AMENDMENT KEY

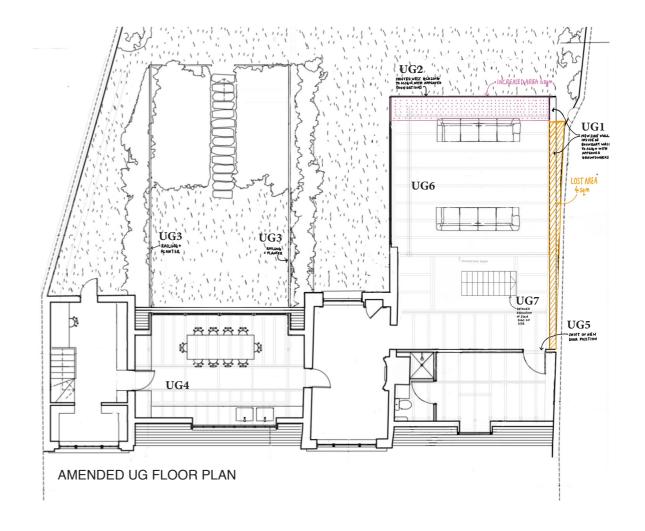
$\label{lem:ug1} \textbf{UG1}. New north side wall to approved rear extension positioned inside of the boundary wall instead of bearing directly into boundary wall to marry with approved groundworks plans (see Amended UG Plan / Amended section DD / Amended Elevation EE)$

$\textbf{UG2.} \ \text{Shifted position of west glazed wall to align with foundation walls and ring beam below to marry with approved groundworks plans (see Amended UG Plan/Amended section DD/ Amended Elevation EE/ Amended Section FF)$

UG3. Proposed planter and railings adjoining garden basement courtyard threshold (see Amended UG Plan/ Amended Elevation EE/ Amended Section FF)

UG4. Replacement of compromised non original 20th century floor joists beneath approved kitchen (see Amended UG Plan)

UG5 Shift in approved door position (see Amended UG Plan)

$\textbf{UG6} \ \textbf{Proposed} \ \textbf{exposed} \ \textbf{rafters} \ \textbf{with} \ \textbf{clay} \ \textbf{tile} \ \textbf{finish} \ \textbf{in-between} \ \textbf{for} \ \textbf{new} \ \textbf{portions} \ \textbf{of} \ \textbf{ceiling} \ \textbf{(see} \ \textbf{Amended} \ \textbf{UG} \ \textbf{Plan)}$

UG7 Refinement to width and position of stair to match exact dimensions on site

Lost Area due to new side wall (4qm)

Gained Area due to marrying with groundwork plans (6sqm)
